# SKEP III Home Office Support Site Visit Report

Consultant	Wahib Medanat Consultant Engineer	Rep No.	13-08062021
Contractor	Derar Saraireh & Sons for Engineering & Contracting	Tender No.	(11/2019/USAID/SKEP/3/S) Schools for a Knowledge Economy Project (SKEP) - Phase (3) Package (1, 2)
Site Name	Khadija Bint Khwailed Basic Mixed School- Shouna Janoubia	Day/ Date	Tue. 08/06/2021
Duration of Project	450 Calendar Days	Total Project Budget	9,789,417.840 JD

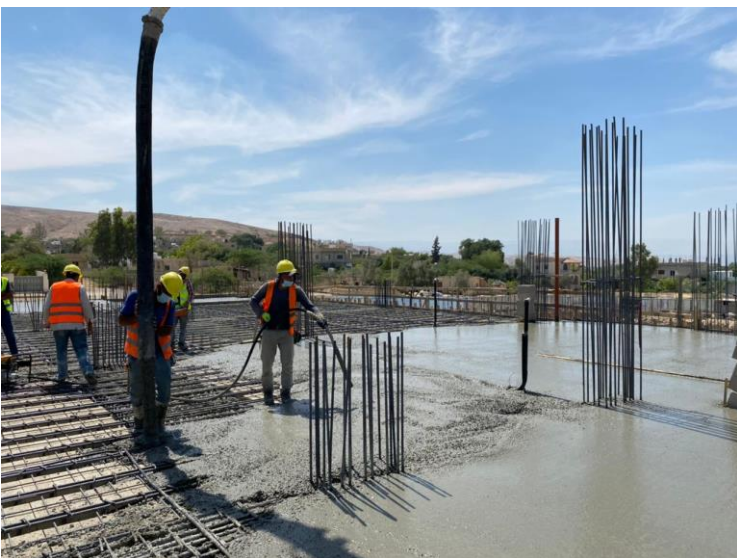
Block work in the school has not started yet
